ADDRESS : 92 SQUIRE ST SUBDIV: AVERY POND 32LOTS  
 CONTRACTOR : WYNN CONSTRUCTION, INC. PHONE : (919) 528-1347  
 OWNER : LITTLE CROSS LLC PHONE :  
 PARCEL : 08-0653- - -0029- -28-  
 APPL NUMBER: 16-50040145 CP NEW RESIDENTIAL (SFD)  
 DIRECTIONS : T/S: 11/10/2016 10:34 AM JBROCK ----  
 AVERY POND #28 OFF OF CHALYBEATE RD

STRUCTURE: 000 000 60X60 4BDR MONO W/ GARAGE & COV POR  
 FLOOD ZONE : FLOOD ZONE X  
 # BEDROOMS : 4000000.00 PROPOSED USE : SFD  
 SEPTIC - EXISTING? : NEW TANK WATER SUPPLY : COUNTY

PERMIT: CPSF 00 CP \* SFD

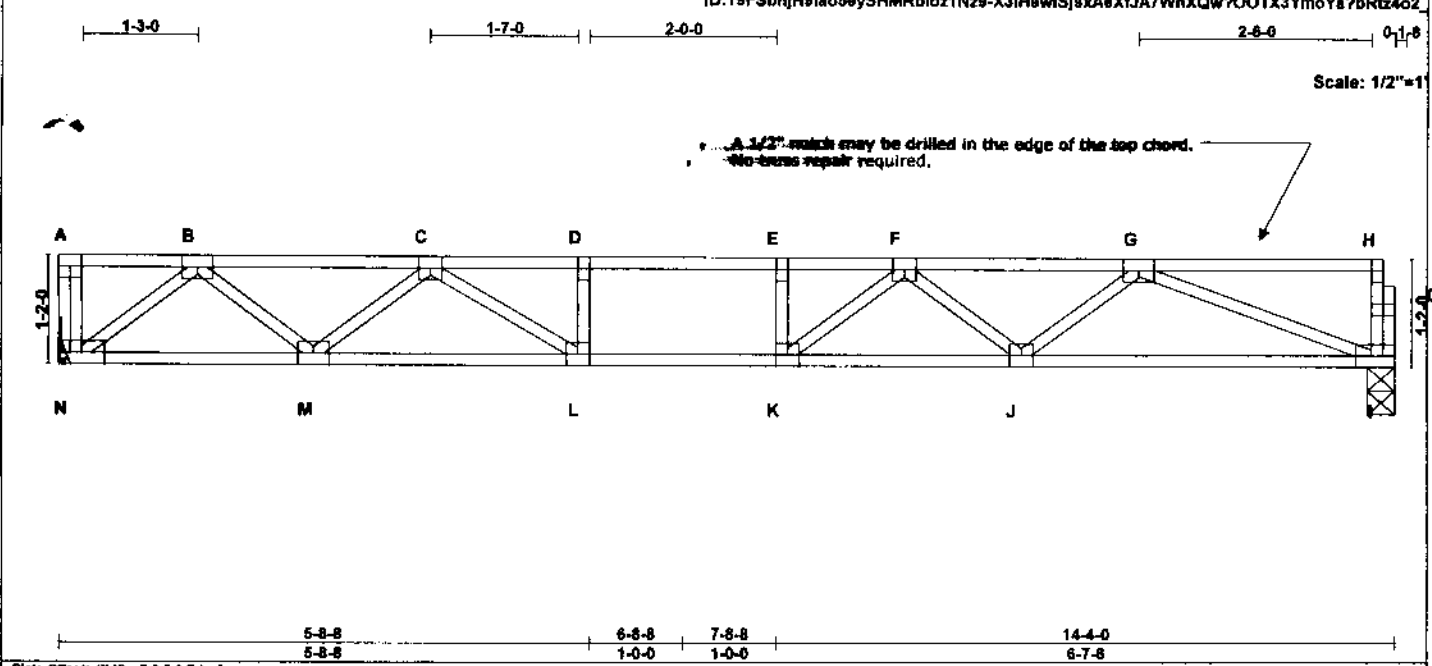
6/12/17	AP	T/S: 06/12/2017 08:52 AM BPETRICH -----
			T/S: 06/12/2017 09:27 AM BPETRICH -----
R425 01	6/13/17	DT	FOUR TRADE ROUGH IN TIME: 17:00 VRU #: 002983740
	6/13/17	DA	T/S: 06/12/2017 01:37 PM LBENNETT -----
			T/S: 06/13/2017 12:41 PM DETAYLOR -----
			Need engineer for bored truss above kitchen
			Completely nail structural guard for plumbing in kitchen
			Strap stud columns
			Replace short nails in hangers
			No test on drain lines
			Okay to side and insulate
I129 01	6/20/17	BS	R*INSULATION INSPECTION TIME: 17:00 VRU #: 002986818
	6/20/17	CA	T/S: 06/19/2017 02:20 PM LLUCAS -----
			T/S: June 20, 2017 01:55 PM BSUTTON -----
R425 02	6/20/17	BS	FOUR TRADE ROUGH IN TIME: 17:00 VRU #: 002986826
	6/20/17	CA	T/S: 06/19/2017 02:20 PM LLUCAS -----
			T/S: June 20, 2017 01:55 PM BSUTTON -----
I129 02	6/21/17	TI	R*INSULATION INSPECTION TIME: 17:00 VRU #: 002987345
	<u>6-21-17</u>	<u>APBS</u>	T/S: 06/20/2017 01:37 PM JBROCK -----

4) Recommend 2x8 strongbacks, on edge, spaced at 10-0-0 oc and fastened to each truss with 3-10d (0.131" X 3") nails. Strongbacks to be attached to walls at their outer ends or restrained by other means.

5) CAUTION, Do not erect truss backwards.  
 6) This repair has been prepared based on information and use conditions supplied by client. Designer has made a good faith effort to outline damage and repair conditions as reported by client. When actual field conditions do not approximate those indicated on this drawing, client shall immediately inform the engineer and refrain from applying the repair.
